**From:** "Maher, William D." <william.maher@exeloncorp.com>  
**To:** "McDowell Bruce (E-mail)" <mcdowell5@lntl.gov>, "Duke Wheeler (E-mail)" <dxw@nrc.gov>  
**Date:** 7/3/03 9:25AM  
**Subject:** Quad Cities ER Pages 2-3 and 2-34 Revised Pages

<<Correction of Quad Acreage 7-3.pdf>>

## **2.1 Location and Features**

**FIGURE 2-3**  
**Site Boundary.**

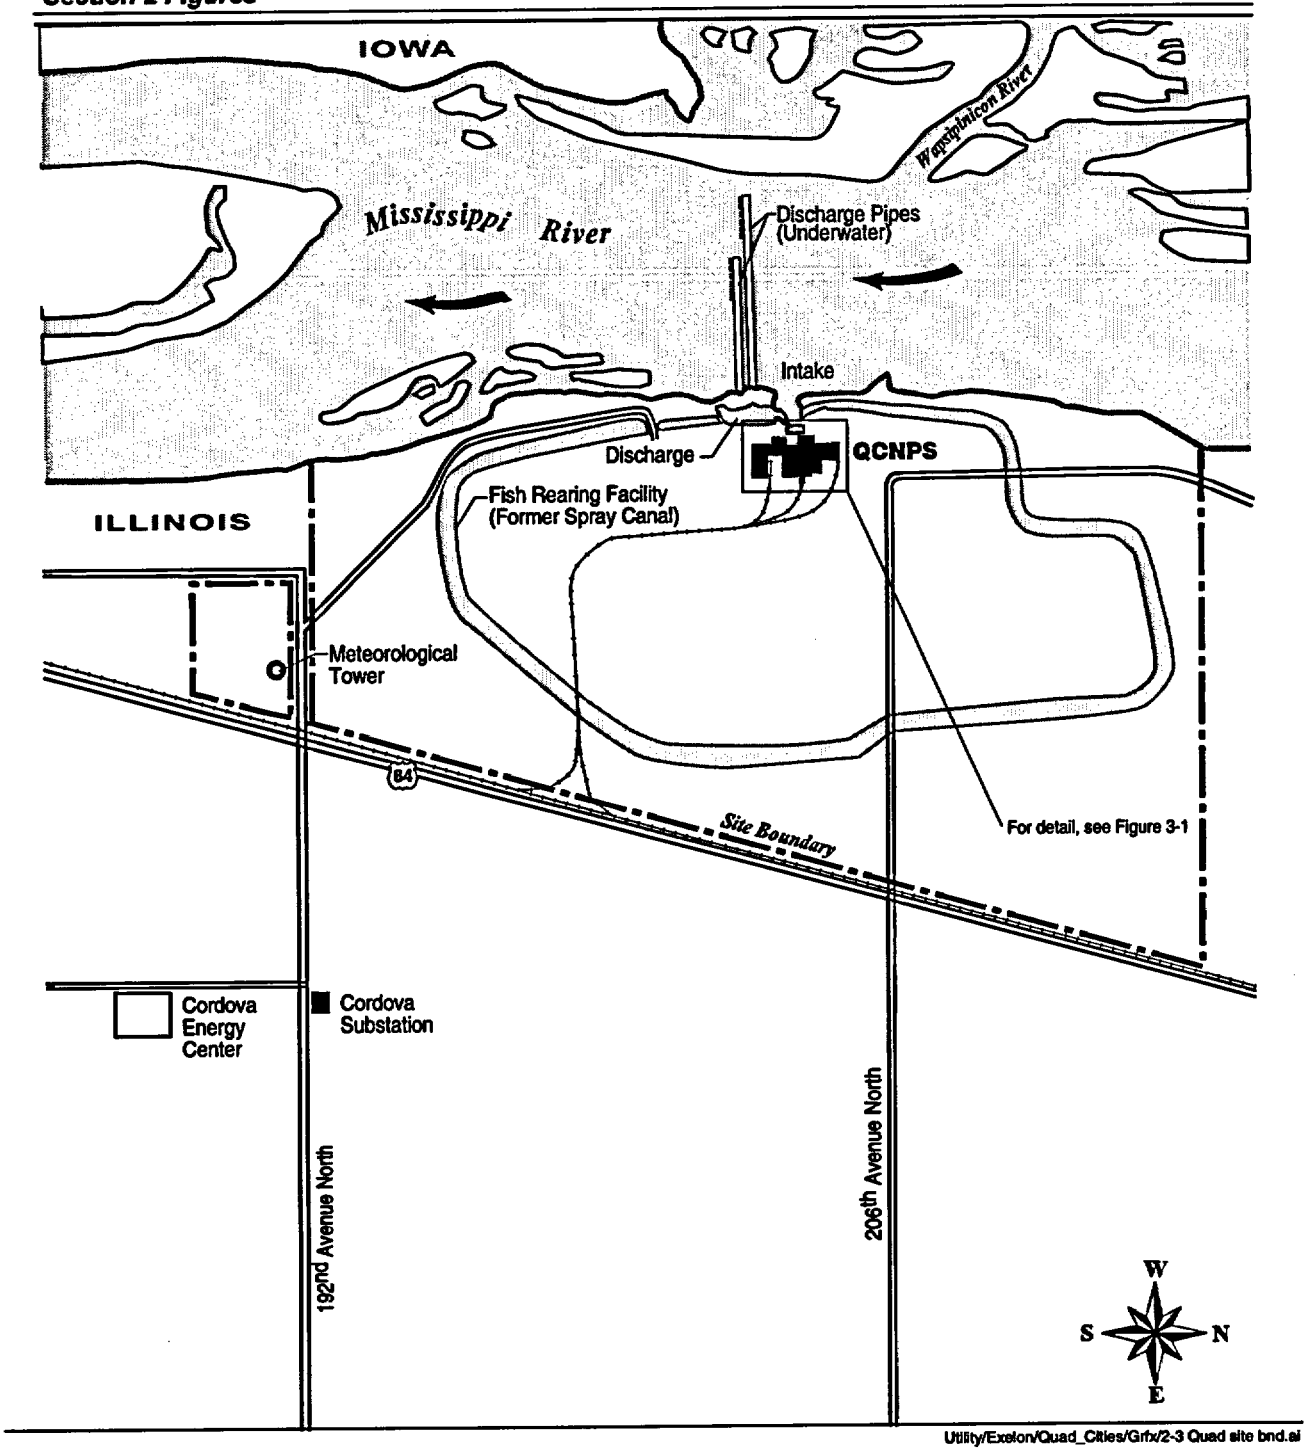
Attached you will find the above referenced pages that can be swapped out for the corresponding pages in the Quad Cities ER.

The QCNPS site consists of 817 acres. In addition to the two nuclear reactors and their turbine buildings, intake and discharge canals, and ancillary buildings, the site includes switchyards and a retired spray canal now utilized to raise fish (Figure 2-3).
